HISTORIC AND DESIGN REVIEW COMMISSION

June 07, 2023

HDRC CASE NO: 2023-196
ADDRESS: 201 N ST MARYS ST
LEGAL DESCRIPTION: NCB 404 BLK 20 LOT 6
ZONING: D, H, RIO-3
CITY COUNCIL DIST.: 1
APPLICANT: Eduardo Robinson/Drury Inn & Suites Riverwalk
OWNER: Larry Westrich/AUBURN INVESTMENTS INC
TYPE OF WORK: Construction of river level patio seating in two locations, modification to existing landscaping beds
APPLICATION RECEIVED: May 16, 2023
60-DAY REVIEW: July 15, 2023
CASE MANAGER: Edward Hall
REQUEST:

The applicant is requesting conceptual approval to construct outdoor dining space and patio space at the river level at 201 N St Mary's. The proposed dining and patio space will be located within existing planter space, located on both the building and river sides of the River Walk path.

SQUARE FOOTAGE:	
PATIO #1	= 356.10 SF.
PATIO #2	= 540.93 SF.
TOTAL	= 897.03 SF.

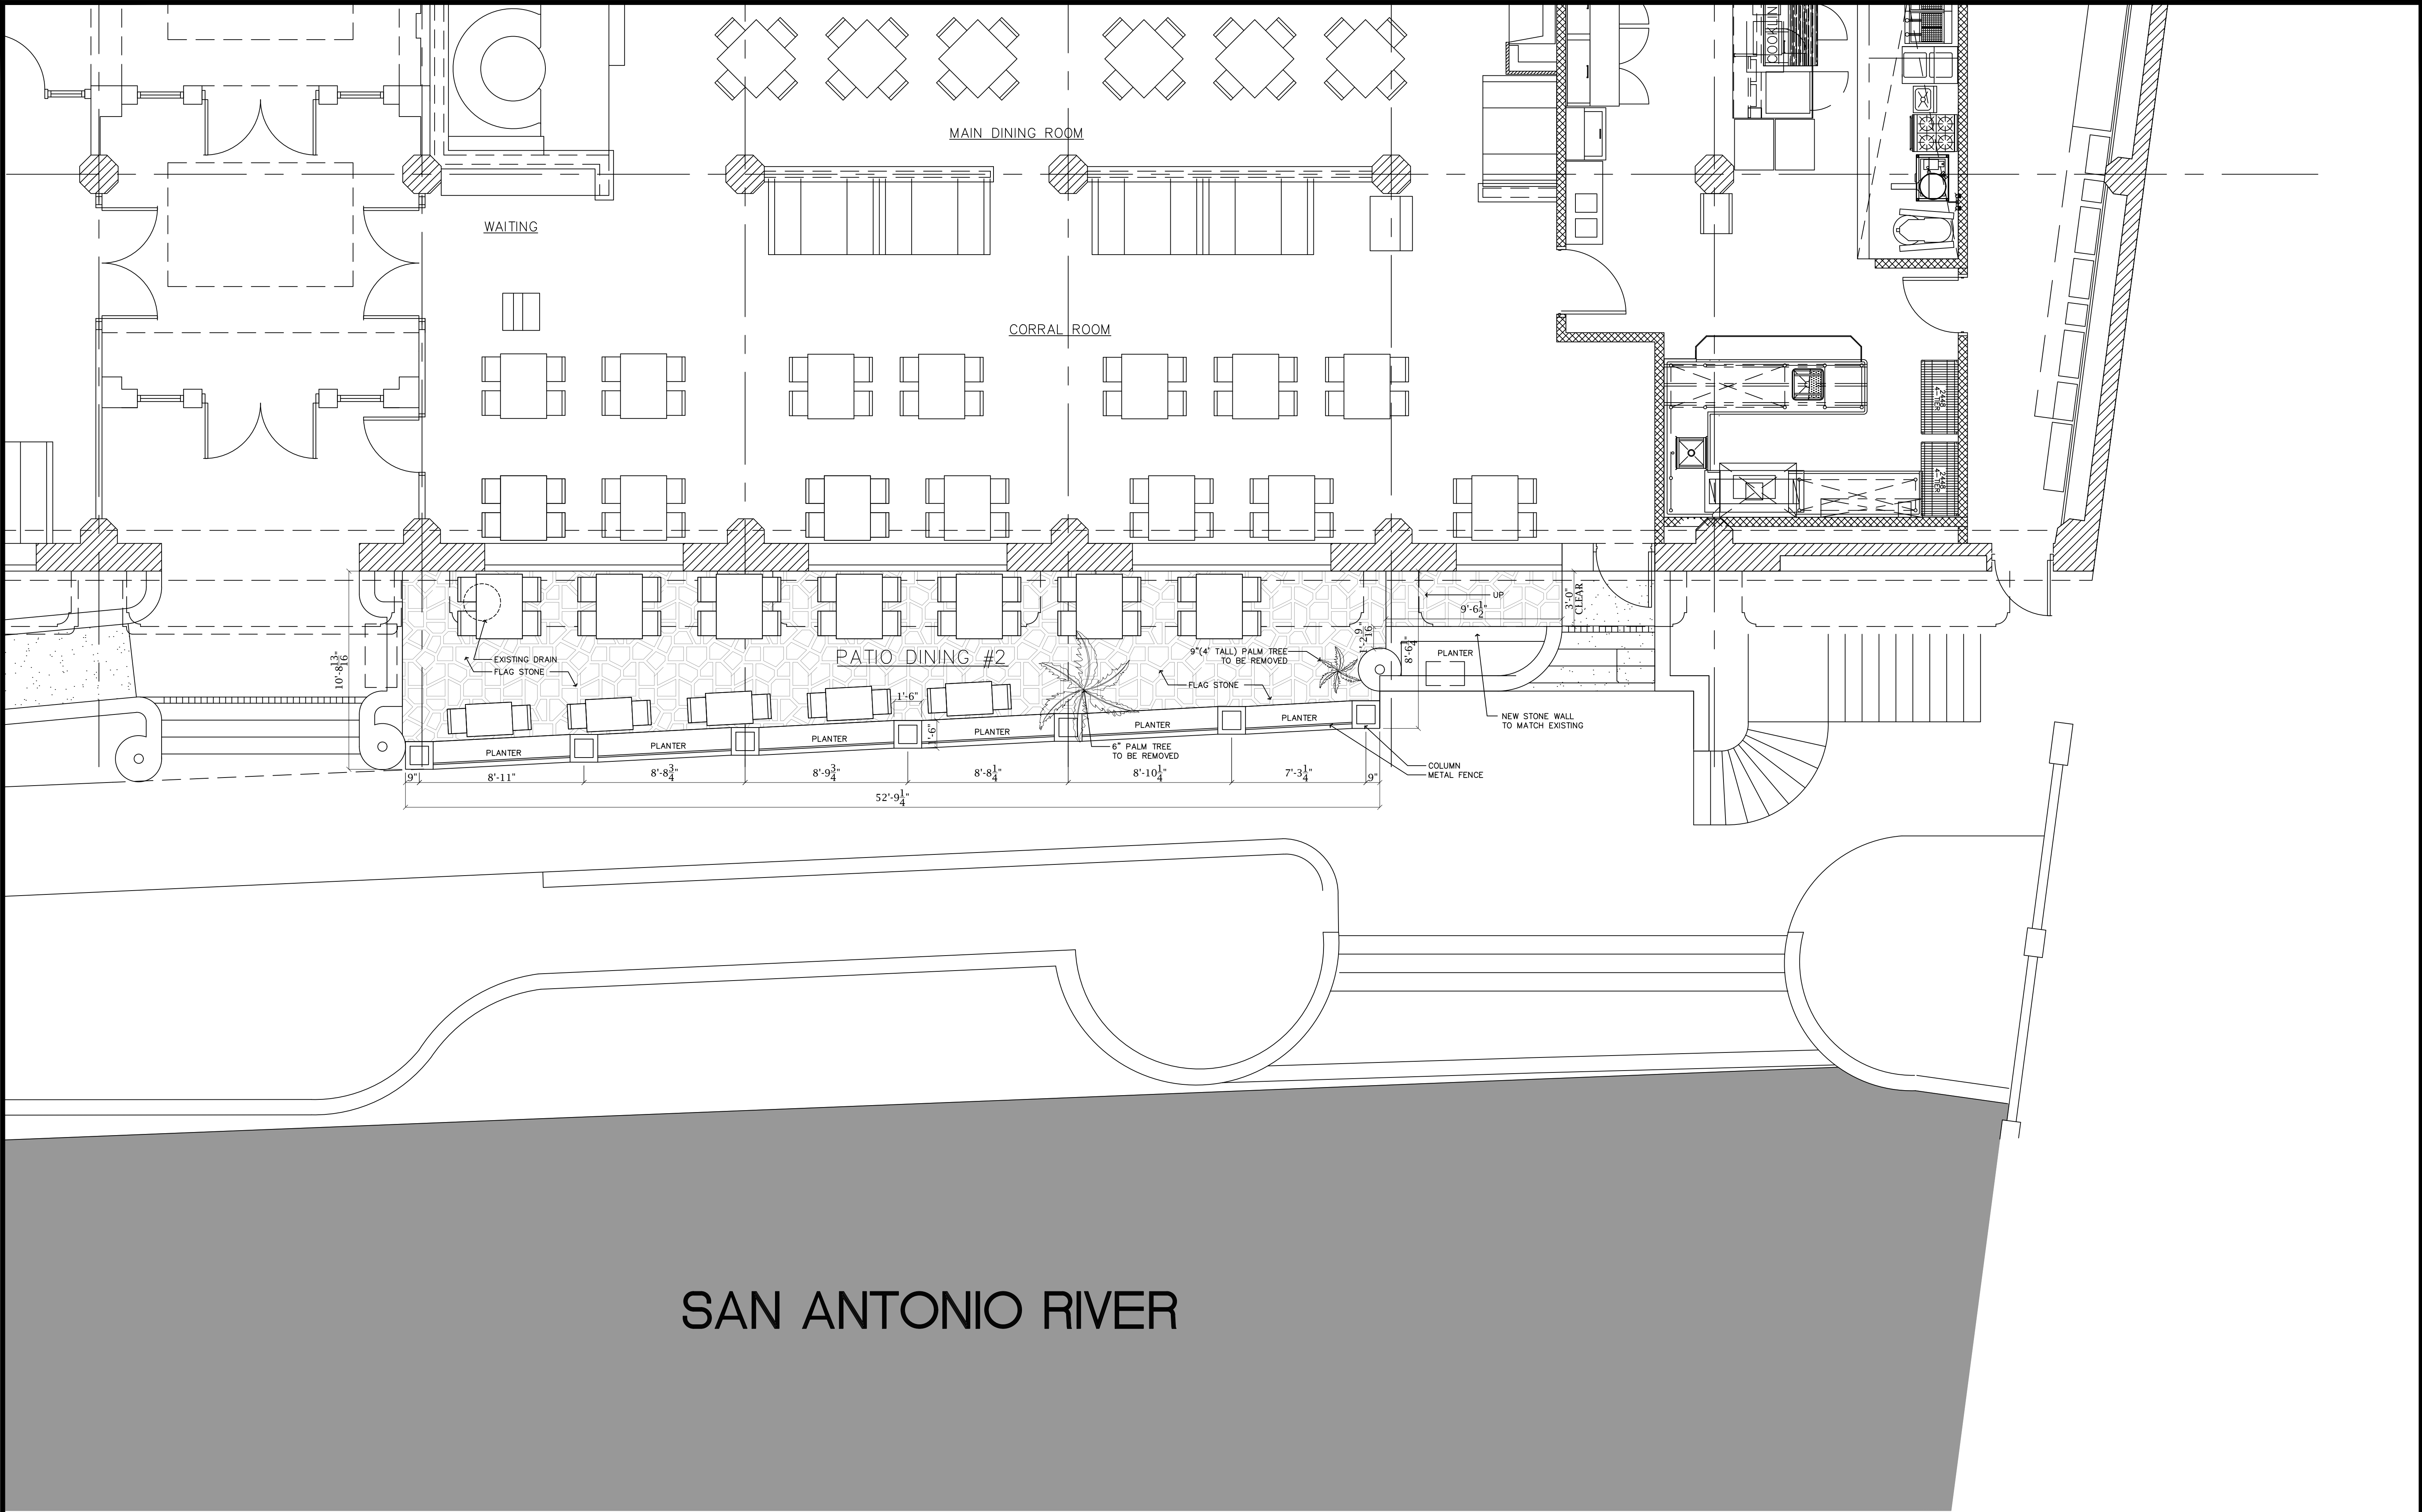
- b. DINING SPACE (Between River & Path) – Between the San Antonio River and the River Walk path, the applicant has proposed to install outdoor dining and patio space to feature approximately 35' – 0" in length and approximately 11' – 0" in depth. The proposed dining and patio space will be located between two existing stone benches. The proposed dining and patio space will require the relocation of an existing trash bin and an existing map, and will require the complete removal of the stump of a removed palm tree, two small cypress trees, and two small palms, as well as various other shrubs and flowering plants. Staff finds both existing cypress trees and existing palm trees as well as the existing trash bin and map on site are to be relocated to other locations on the River Walk, in coordination with Center City Development and Operations Department.

- c. DINING SPACE MATERIALS (Between River & Path) – The applicant has proposed materials that include flagstone paving with brick edging. Generally, staff finds the proposed materials to be appropriate as they complement the existing paving at the River Walk level. Staff finds that additional information and detailing should be provided regarding the railing and retaining wall at the river side. Original Hugman elements should not be modified or impacted to accommodate new site seating or paving.

- d. DINING SPACE (Between Building & Path) – Between the existing structure and the public pathway at the river level, the applicant has proposed to install outdoor dining and patio space to feature approximately 53' – 0" in length and approximately 11' – 0" in depth. The proposed dining and patio space will be located between two existing stair and entrance elements at the basement level of the building addressed as 201 N St Mary's. The applicant has proposed for the dining space to be slightly lower in elevation than the adjacent River Walk path and to be separated from the River Walk path by a stone planter wall featuring planting beds, stone columns, stucco knee walls and metal fence pickets. While staff finds the installation of a barrier between dining space and the pedestrian path to be appropriate, staff finds that the wall should be reduced in height to the maximum extent possible while meeting code requirements. The installation of the proposed dining and patio space will require the removal of two existing palm trees and various other low growth plants. Staff finds that both palm trees should be relocated to other locations on the River Walk in coordination with Center City Development and Operations Department.

- e. DINING SPACE MATERIALS (Between Building & Path) – The applicant has proposed materials that include flag stone. Staff finds flagstone paving to be appropriate and complementary of the historic paving at the river level. As noted in finding d, staff finds that the proposed wall should be modified to be consistent with historic low and landscaping walls found on the River Walk.

- i. That all impacted cypress and palm trees as well as flowering plants be relocated to other locations along the River Walk with coordinate through the Center City Development and Operations Department.
- ii. That the wall be reduced in height to the maximum extent possible while meeting code requirements.
- iii. That all existing trash bins, maps, and other public infrastructure be relocated in coordination with the Center City Development and Operations Department.
- iv. That all patio furniture be consistent with the UDC, as noted in finding f.
- v. That the applicant provide info about fenestration changes to the building as part of a request for a Certificate of Appropriateness.
- vi. Archaeology – The project shall comply with all federal, state, and local laws, rules, and regulations regarding archaeology, as applicable.
